Independent Advisory Panel to IDB Invest
IAP Report N° 1, September 2018

Ituango Hydropower Project
Colombia

Report N° 1, September 2018 Ituango Hydropower Project – Colombia

Figure No.14: Section from the analyses of the “El Romerito” landslide (June 2018 Designer Report “Diagnostico Geológico Geotécnico de la Contingencia”)

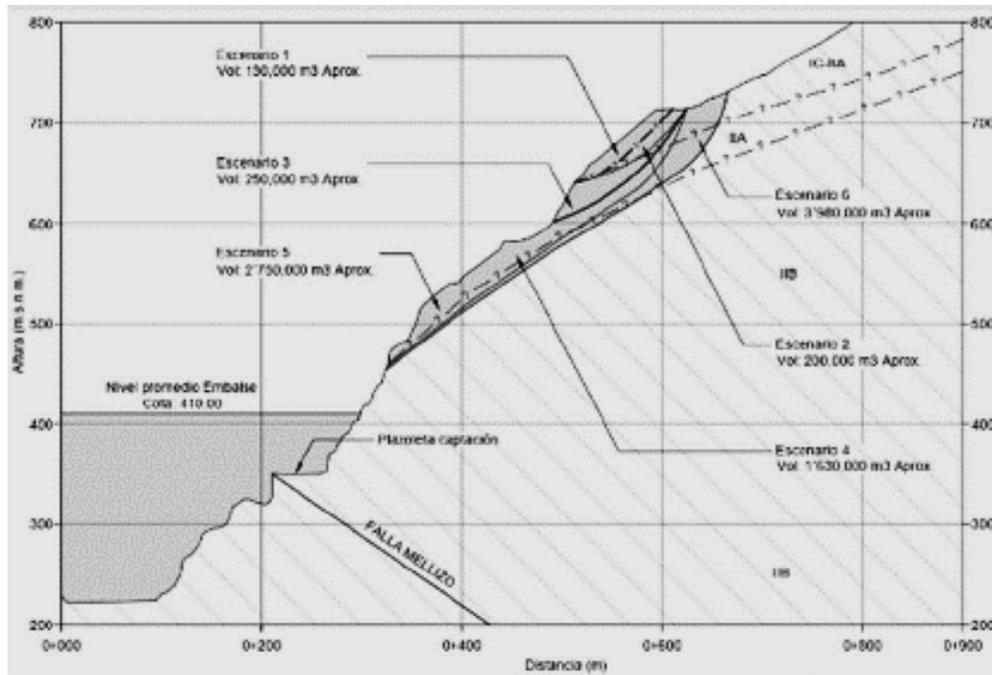
Although not familiar with this type of analysis, the IAP understand that it is a crude estimation of the potential extent of landslide movements, which are qualitatively compared to field evidence. Based on this comparison, the Designer considers that the possibility of a deeper failure, involving significant part of the weathered bedrock, is negligible. This conclusion has to be validated considering the current equilibrium state and future slope movements (if any). Involvement of a larger mass could manifest at a later stage, due to creep movements and gradual transition to residual shear strength of materials.

The Designer also carried out a series of probabilistic slope stability analyses, to evaluate the probability of failure of shallow slides, i.e. scenarios 1 to 3. The IAP has the following observations/suggestions:

- The methodology for defining and examining failure surfaces per scenario is not clear in the report. The available images illustrate one representative failure surface for each scenario, together with some sets of very different failure surfaces. The IAP suggests focusing the sensitivity analyses on surfaces similar to the representative one. This can be done either by drawing more surfaces or by using the optimization tool of the software. The particular tool makes geometrical

Figure No.16: Global stability of the caverns and possible influence to the parietal slope (from the Designer report, “Diagnóstico Geológico Geotécnico de la Contingencia” June 2018)

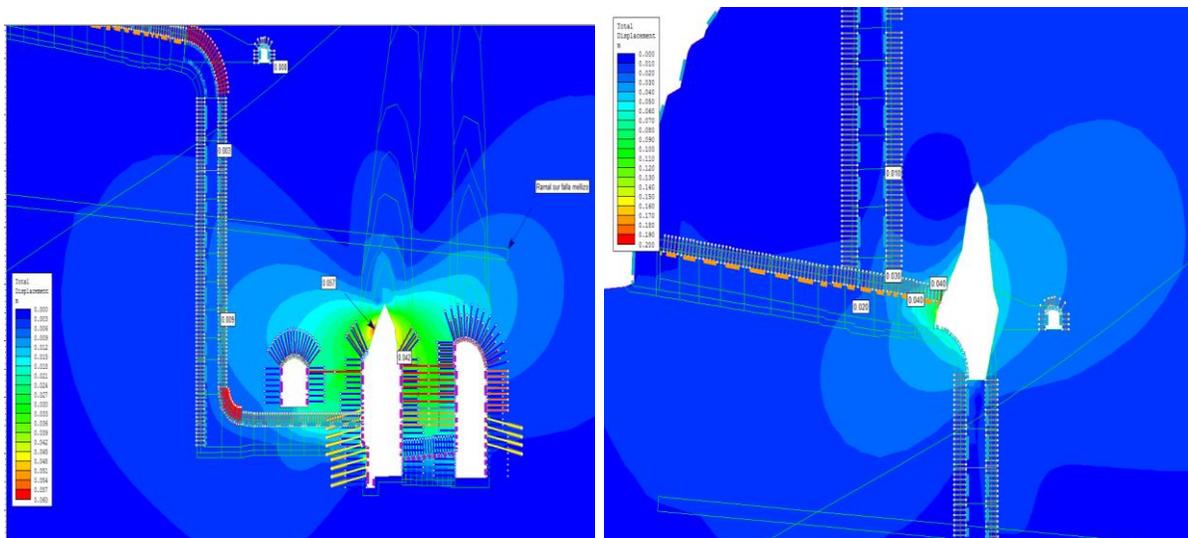
The FEM analyses (see Figure No.16) show that any extended collapse is not likely to affect the stability of the parietal slope and adjacent access tunnel.

Figure No.20: Ituango Core-Rockfill Dam - Typical section and parameters

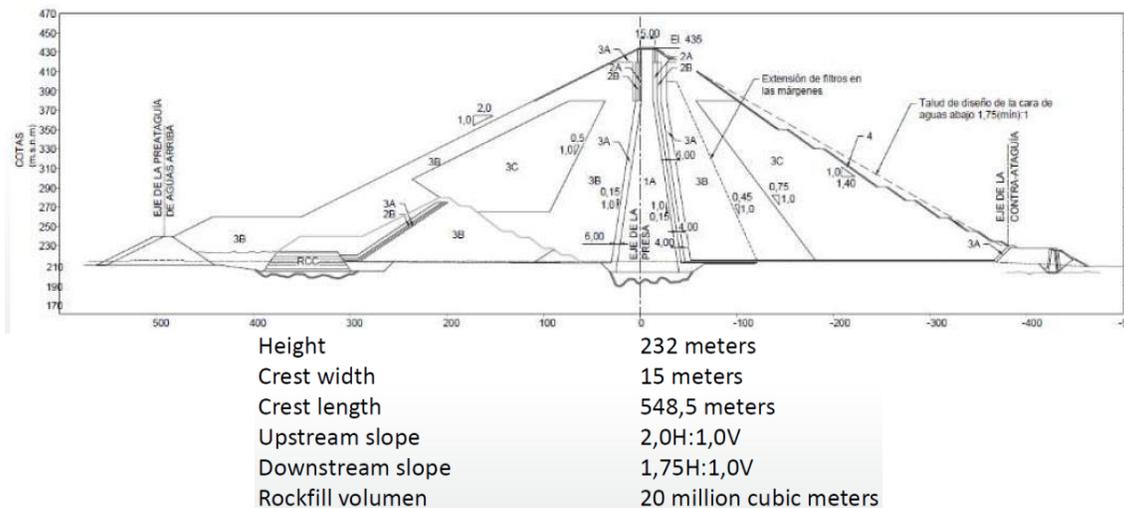
The IAP has no major comments on the design of the dam. Based on the data provided, clay core, zoning, filter design, materials, static and dynamic analysis, and instrumentation of Ituango Dam, respond to engineering best practice in dam design².

The characteristics of the materials, as ascertained by laboratory and field tests, are adequate. Filter and transition zones meet grading specifications.

The IAP understands that the comments made about the right foundation of the core were properly addressed (“Control de elaboración, revisión, verificación, aprobación y distribución de informes”, 18/8/16). The IAP also concurs with the suggestions of the Board of Advisors (report #12, February 2017) on the plasticity of the base of the core, the width of filters and the upstream extension of the filters.

Figure No.21: Priority Embankment design

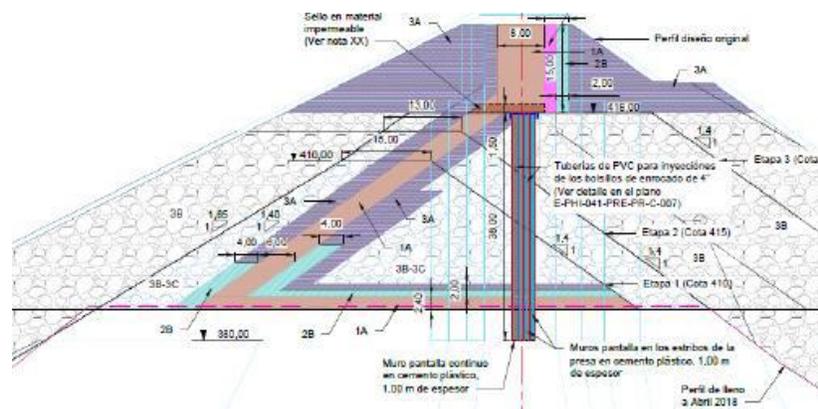
Dam zoning was modified, above el. 385 m asl, to speed up embankment rising during emergency response. A plastic diaphragm is being constructed to improve water tightness of the zone (see Figure No.21).

The Designer is investigating the global stability of that part of the dam (Diagnóstico Geológico Geotécnico de la Contingencia, June 2018).

Figure No.29: Perfil del Delta de Sedimentos para periodos de 25, 50 y 100 años de Operacion del Embalse

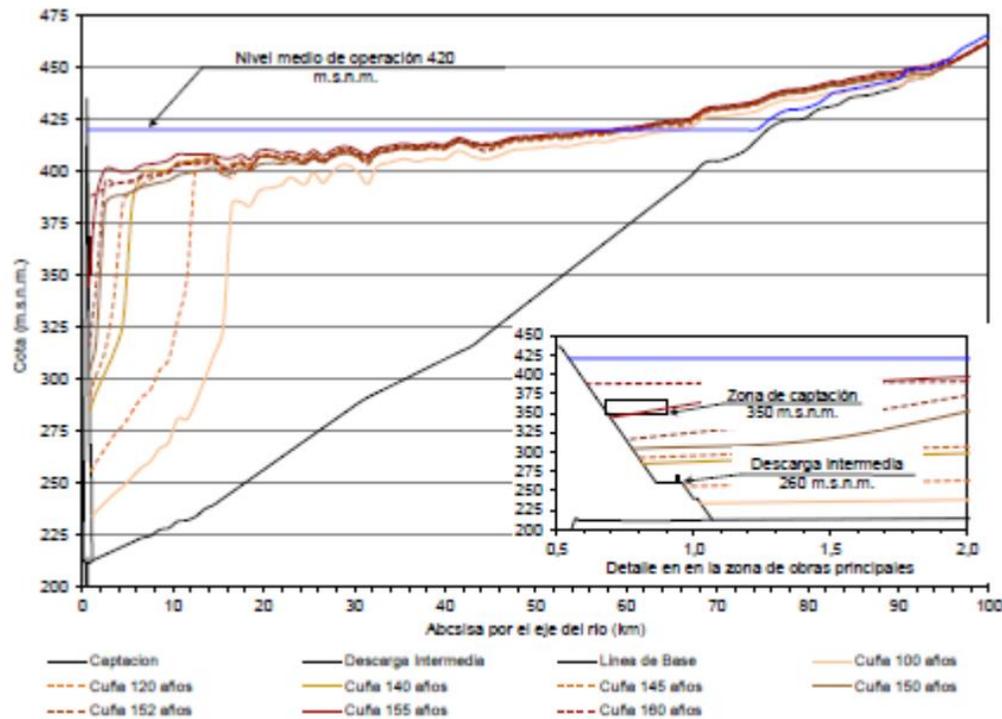
The Designer has examined the subject⁹ and figure No. 29 shows the advance of the sediment delta during the operational life of Ituango's reservoir.

The Designer conclusions are that the delta's coarse sediments could reach the power intakes after 150 years of plant operation, or 75 years in case sediment yield doubles.

Figure No.30: Reservoir sedimentation – Ituango case

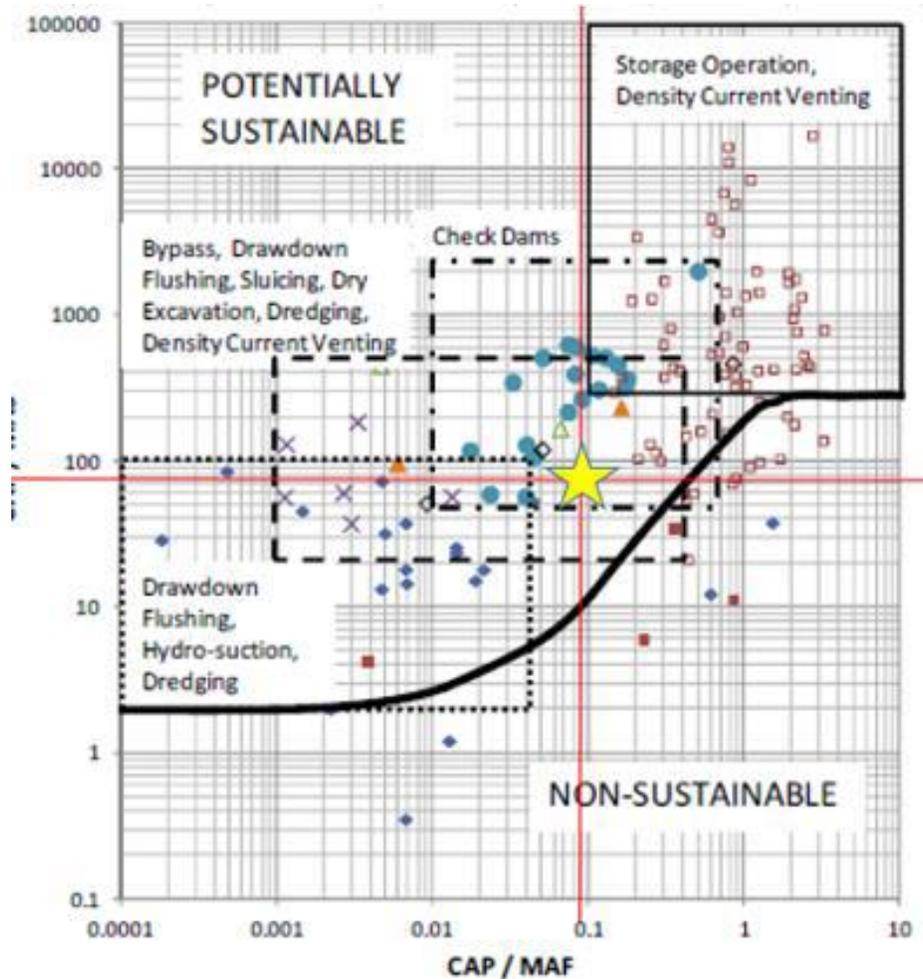
The representative point of Ituango is plotted in figure No.30¹¹

A CAP/MAF ratio lower than 0.2 indicates a hydrologically small reservoir. The CAP/MAS ratio provides a rough estimate of the reservoir life, without consideration of the reservoir trap efficiency. Taking trap efficiency into account, reservoir half-life could be in the order of 50 to 60 years.
